Project #21-033
Café Zupas
Located at 701 North Main Street

REPORT SUMMARY...

Project Name: Café Zupas
Proponent/Owner: Christian Wilson / CA Fullmer Family LLC
Project Address: 701 North Main Street
Request: Design Review Permit
Current Zoning: Commercial (COM)
Date of Hearing: June 24th 2021
Type of Action: Quasi-Judicial
Submitted By: Russ Holley, Senior Planner

Staff recommends that the Planning Commission **approve** a Design Review Permit for Project #21-033 Café Zupas for a 3,600 SF commercial building located at approximately 701 North Main Street; TIN #05-048-0024; -0044.

Figure 2 shows the site plan

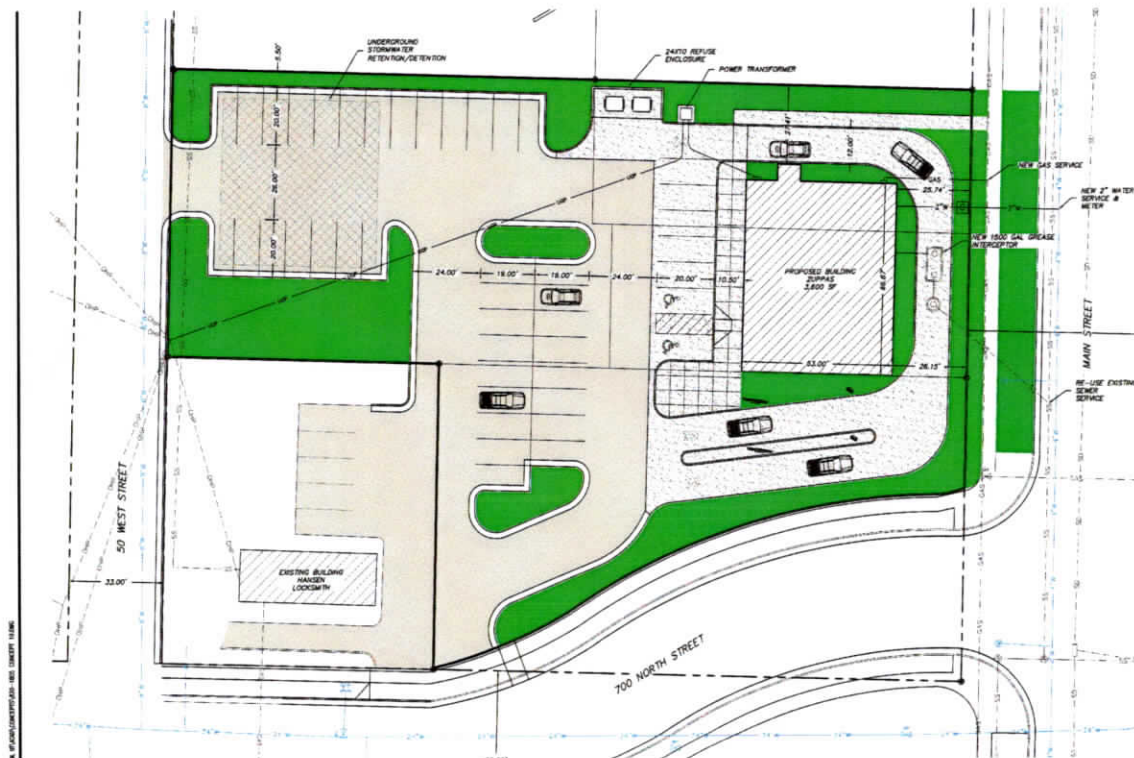
The LDC 17.10.030 requires parking lots to be placed behind or in secondary locations to the primary buildings. Pedestrian circulation should be safe and convenient that results in sidewalks connecting streets to building entrances. The site layout generally places the building closer to the street, but the circulating drive-thru lane presents a pedestrian barrier. The submittal shows a sidewalk around the north side of the drive-thru and connecting to the entrance on the west side. As proposed, the proposed project meets the requirements in the LDC.

4. The sidewalk connecting the building to Main Street along the north property line shall have curb cuts and painted crosswalks over the drive thru aisle.

5. A raised curb island shall be placed along the south side of the drive-thru lane to sufficiently provide space between the northern most parking stall and the vehicles turning and exiting the drive-thru lane.

A1 EAST FACADE (MAIN STREET)

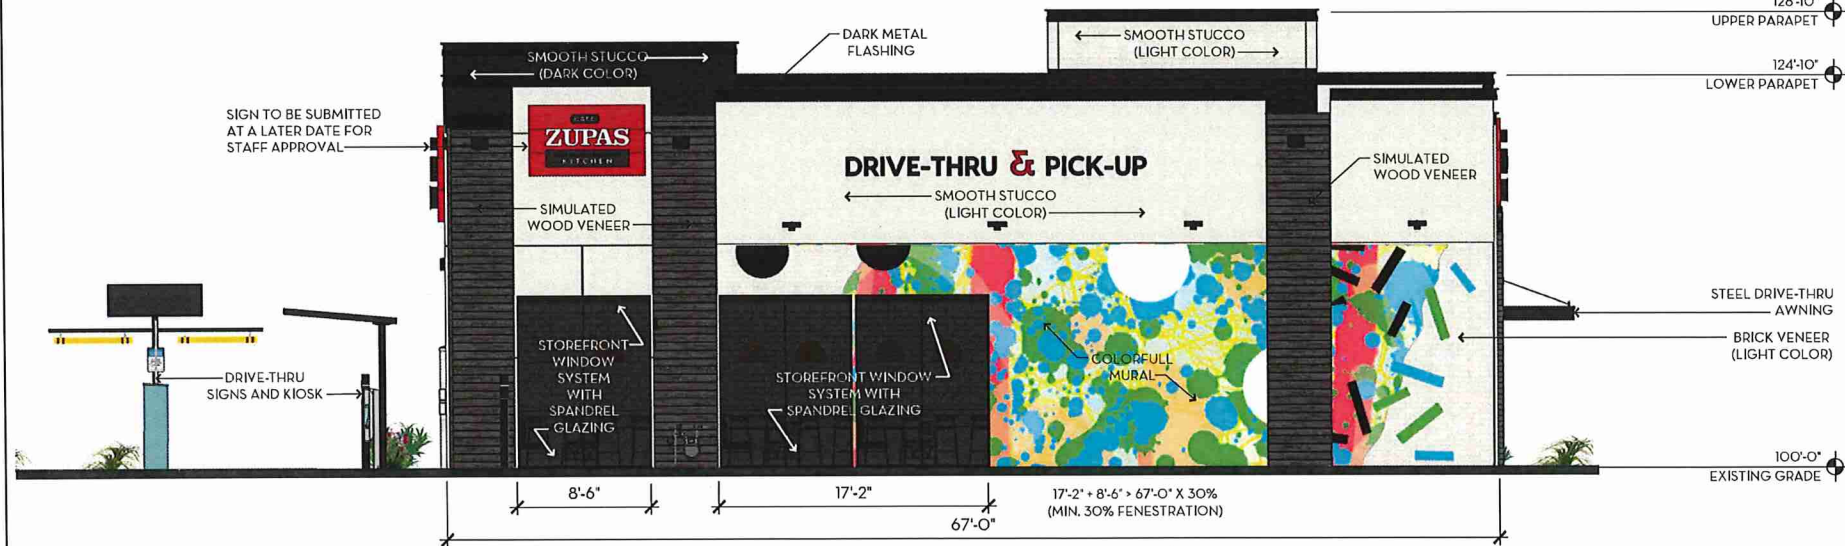
primary entrance, to have 30% transparency (fenestration). The LDC limits blank or featureless walls in the COM zone to no more than 40 linear feet. The proposed building shows the primary façade and entrance facing westward towards the parking lot, opposite of Main Street. The façade facing main street does have similar features and details found on the west (primary) façade, with spandrel glass, stucco, wood veneering, parapet variations and a large painted mural. Not considering the parapet space, the Main Street façade is approximately 1340 SF and the proposed three (3) spandrel windows total 308 SF for a 22.9% transparency (8% below the standard). Murals containing purely art content are reviewed and approved by the Planning Commission as per LDC 17.43.040 (wall art over 10%). Murals that contain commercial signage are limited to 10% of the total wall area. The proposed mural does not contain commercial signage within the artwork. As conditioned with Main Street windows (spandrel) increasing to 30% transparency, the building design meets LDC standards.

1. All standard conditions of approval will be recorded with the Design Review and are available in the Community Development Department.
2. The building transparency on the Main Street façade shall be at least 30% transparency unless the Planning Commission approves an alternative based on LDC 17.43.080.
3. The Building Frontage shall increase to 50% along Main Street unless the Planning Commission approves an alternative based on LDC 17.43.080
